SUPPLEMENT TO ENVIRONMENTAL REPORT  
MOAB, UTAH FACILITY  
FOR ATLAS MINERALS

7/9/74

Dames & Moore Job No. 5467-003-06

This report presents the results of our additional engineering studies of the Atlas Minerals uranium milling facility near Moab, Utah. This report was prepared in response to the 27 questions posed by the Atomic Energy Commission in a letter dated January 25, 1974 concerning the "Environmental Report, Moab, Utah Facility," by Atlas Minerals Division of Atlas Corporation, dated August 31, 1973. A previous study by Dames & Moore entitled "Report of Engineering Studies, Tailings Pond Embankment System, Moab, Utah, For Atlas Minerals," dated March 28, 1973 was included in the environmental report as Appendix A. Information and data presented in these reports were drawn upon for this response.

PLATE 6C

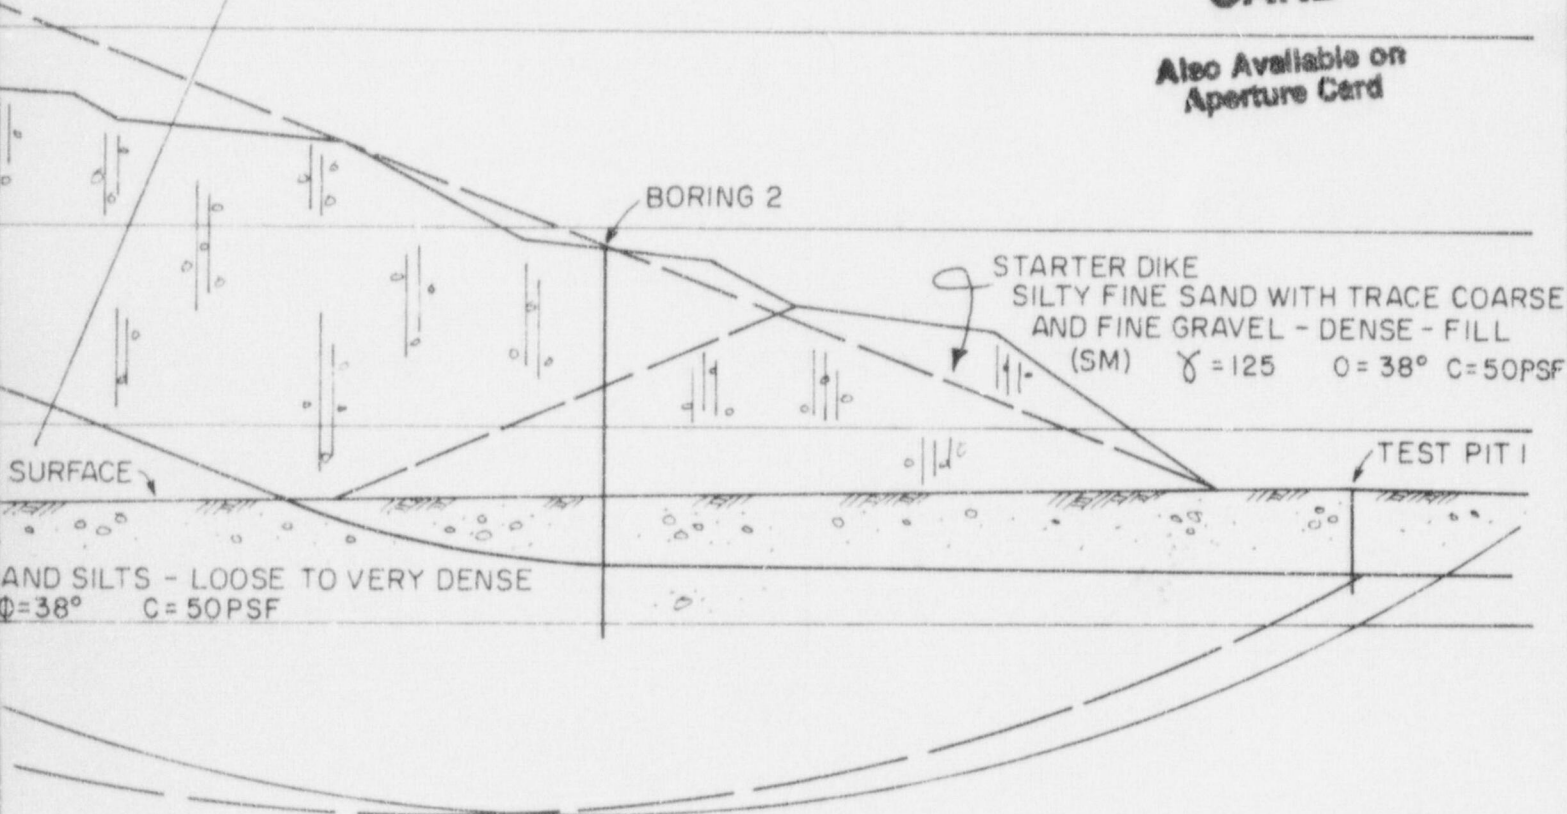
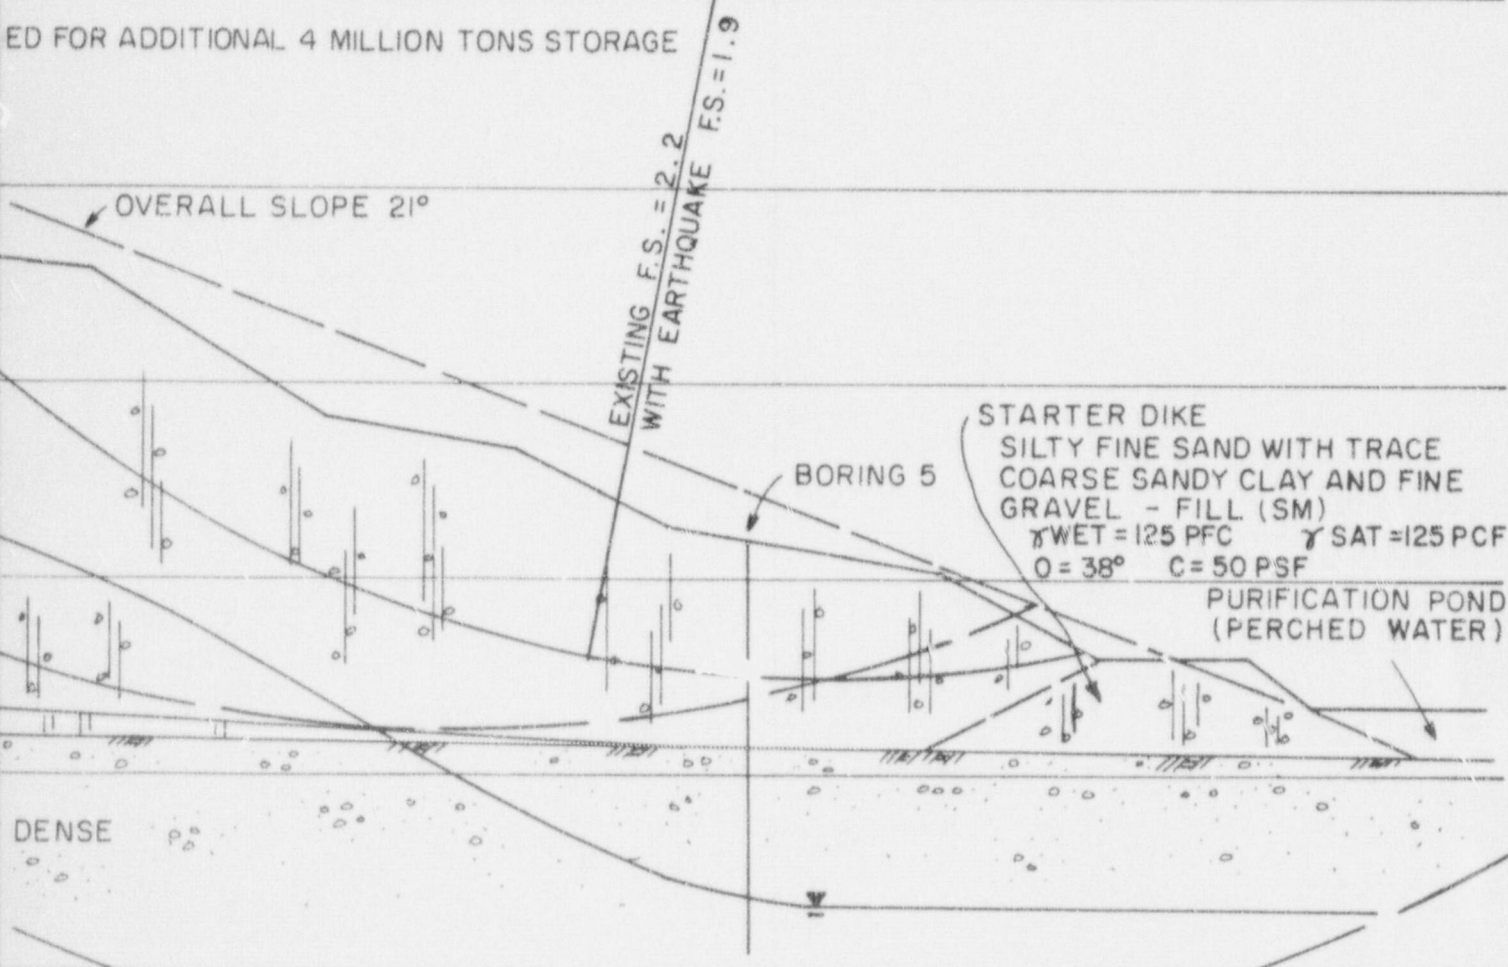
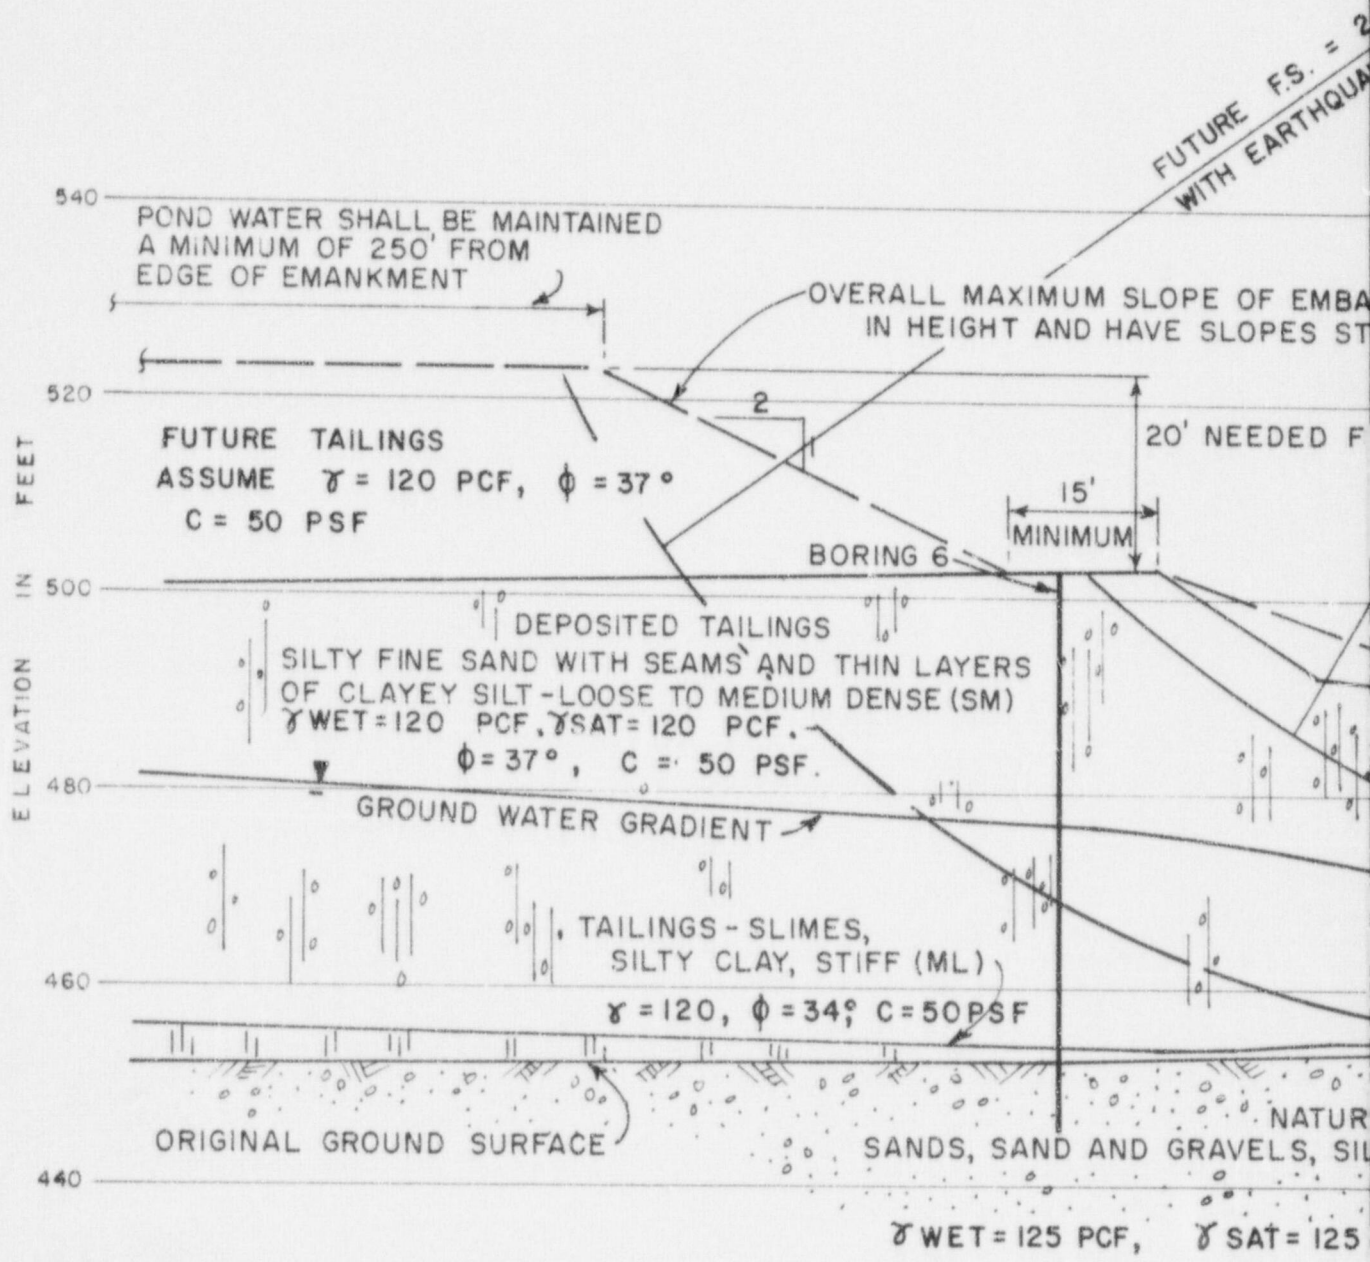
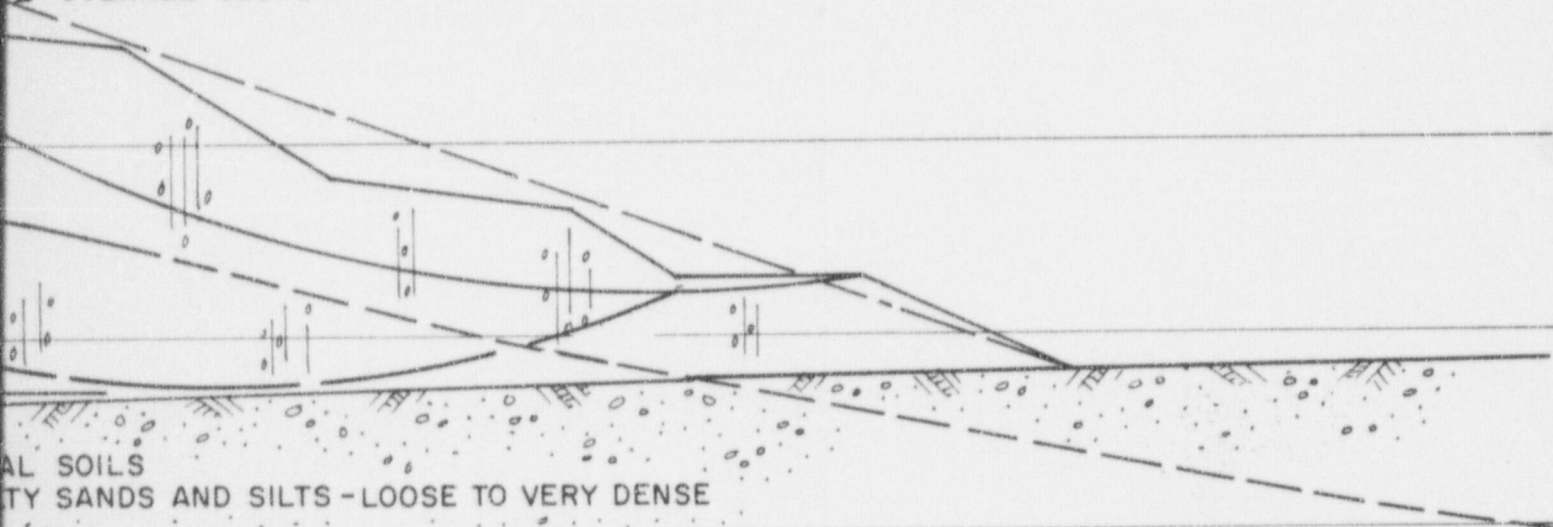
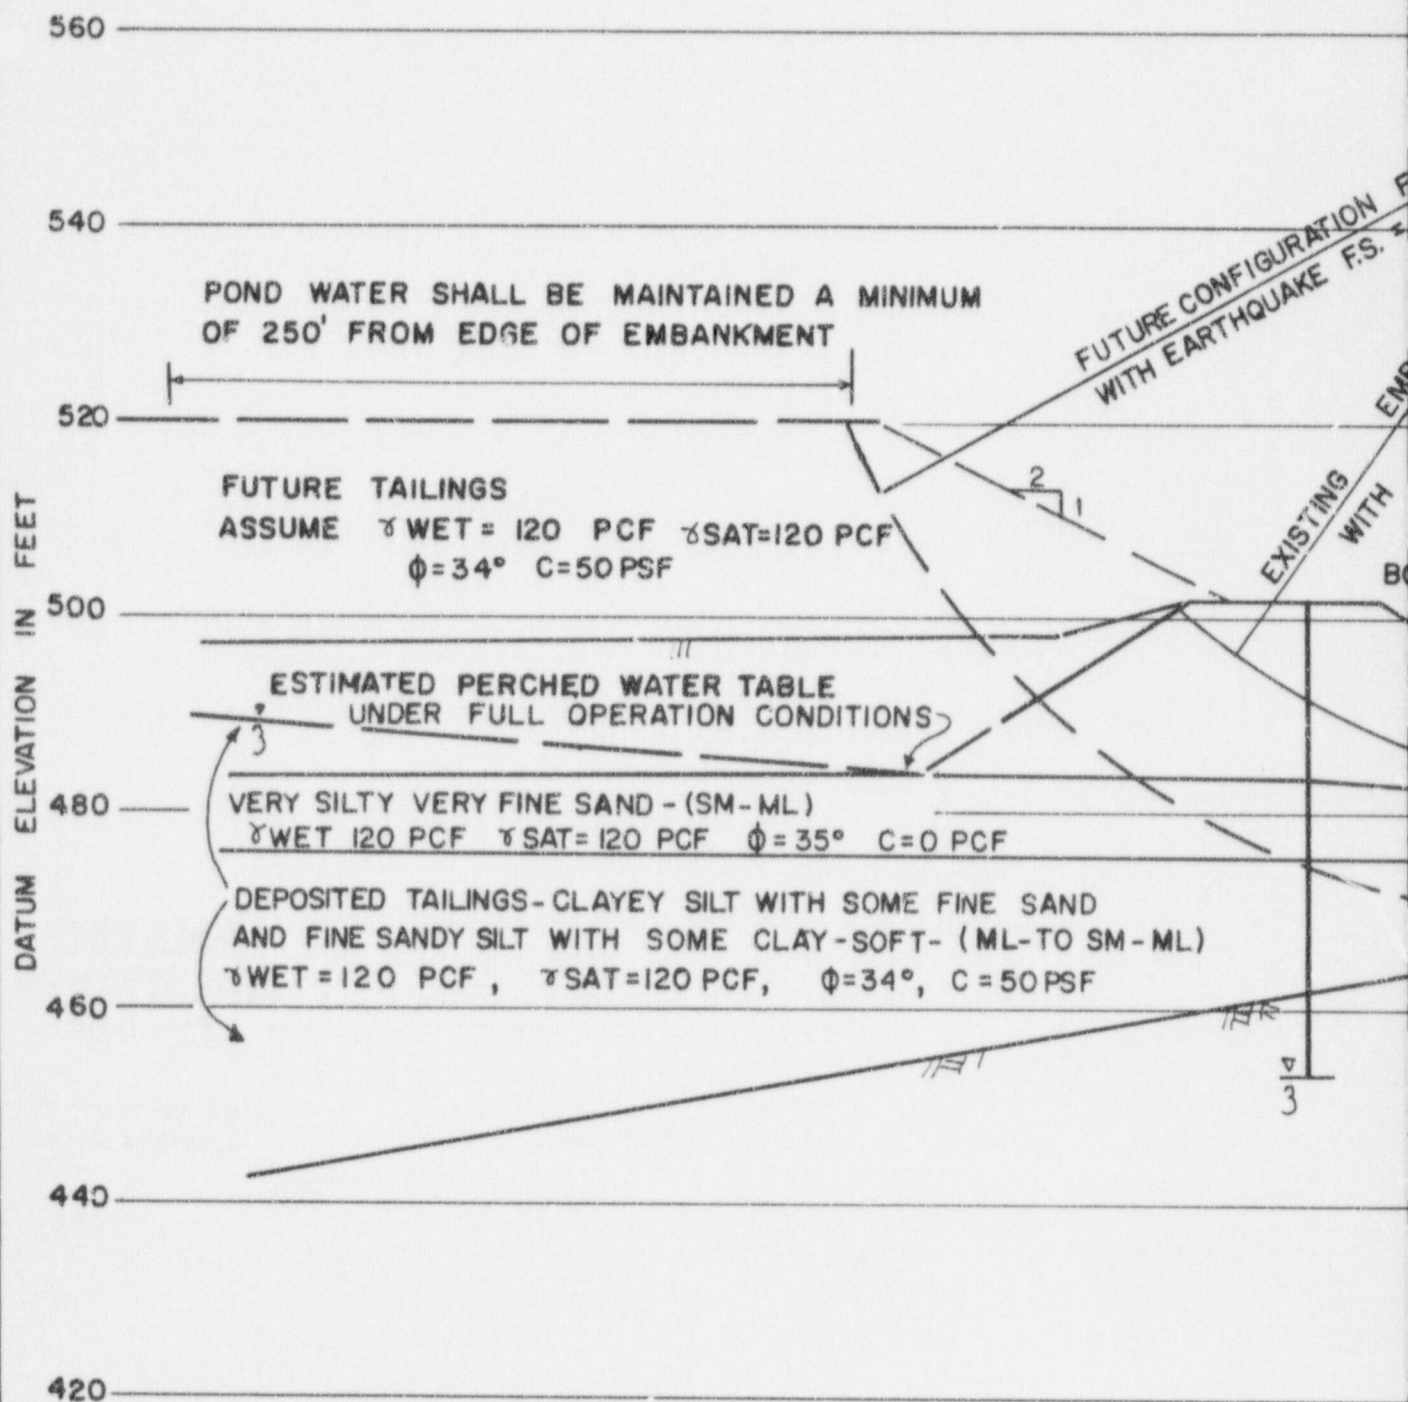
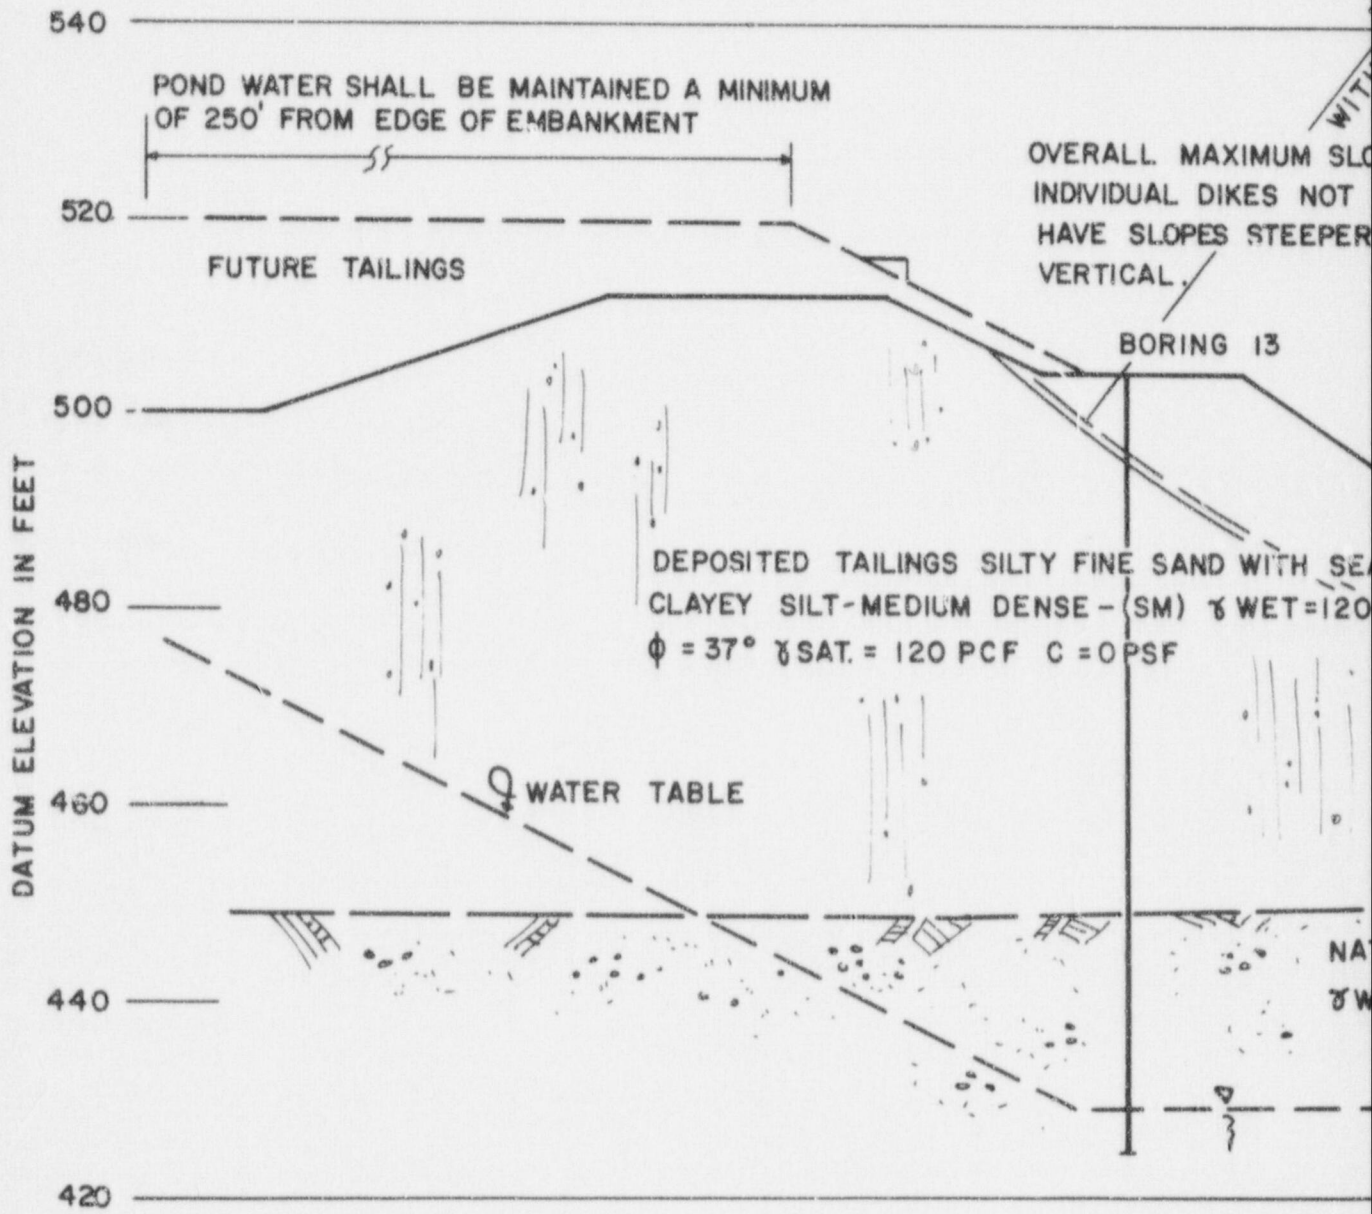
9.12 REPLY TO A.E.C. QUESTION 11:

The logs of additional borings drilled in the embankment and site vicinity are presented in Appendix A of this report. The locations of the borings are shown on Plate 2, Plot Plan. Additional cross-section and results of the stability analyses calculated for these sections are presented in graphical form on Plates 6A through 6F.
